Great River Hydro

**Re: Great River Hydro, LLC; FERC Project Nos. 1855-050, 1892-030 and 1904-078;
Response to FERC Additional Information Request dated April 30, 2021**

Responses to AIR issued April 30, 2021

Figure A2-1. Comparison of monthly volumetric flow totals at the Bellows Falls Project for the year 2015 under current (historic) operation, simulated IEO, and proposed simulated IEO/Flex.

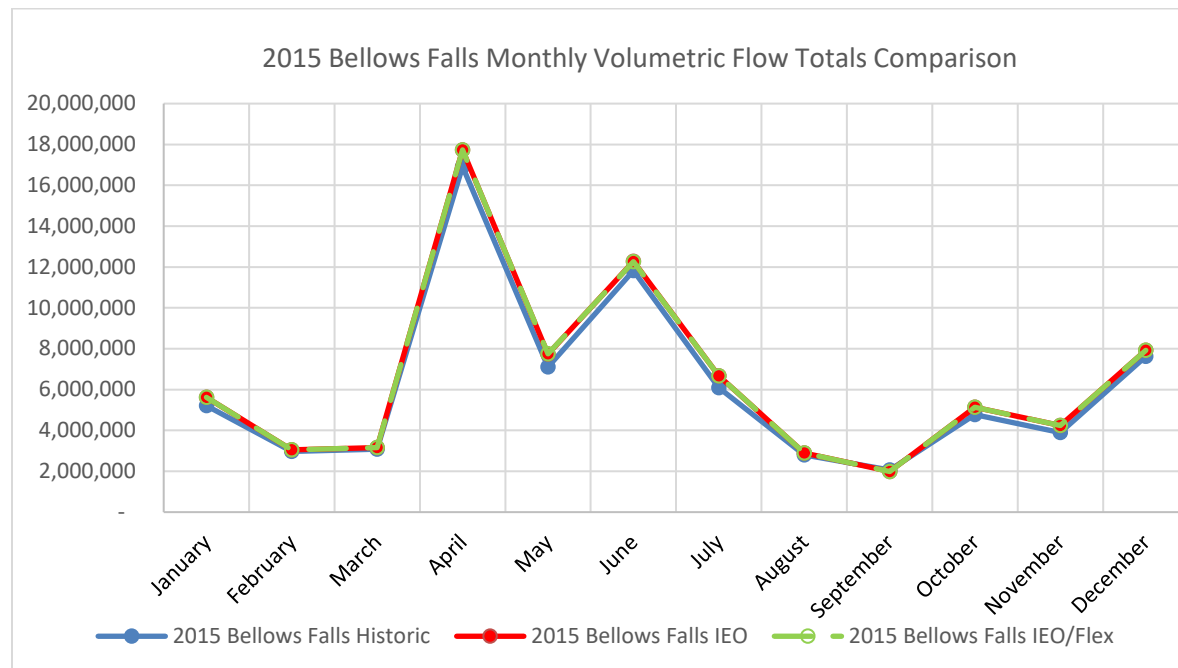
AIR2: The simulation model outputs for run-of-river operation in 2009, 2015, 2016, and 2017, filed on March 30, 2021, include significantly higher water volumes than actual, historical water volumes at each project. The differences are significant on a monthly and annual basis, and are not consistent between projects, with the Bellows Falls Project having the largest relative difference between modeled and historical volumes. Please revise the response to staff's February 12, 2021 letter, so that the simulation model outputs for run-of-river operation (e.g., flow releases from each dam and powerhouse), include monthly water volumes that are accurate to within 1 percent of the actual monthly historical water volumes for each project for 2009, 2015, 2016, and 2017.

Side-by-side comparisons of Current Operation, IEO and IEO/Flex operation hourly flows for each project for each of the four years is provided in the spreadsheet attachment to this AIR response in tabs labeled: 2009 Flows; 2015 Flows; 2016 Flows; and 2017 Flows. Additionally, charts depicting the monthly volumetric total for each of these three operational modes are provided in the spreadsheet under tabs labeled: 2009 Monthly Q Volume Chart; 2015 Monthly Q Volume Chart; 2016 Monthly Q Volume Chart; and 2017 Monthly Q Volume Chart. By observing these charts one can see that while the flows are different, they track closely with one

another (monthly distributions are similar) and that is more important that volumetric totals for the purpose of evaluating impacts and depicting the GRH Proposed Alternative Operation. Annual Volumetric Totals are summarized in Table A2-1 below. An example of the Monthly Volumetric Flow Total comparison chart is shown below as Figure A2-1.
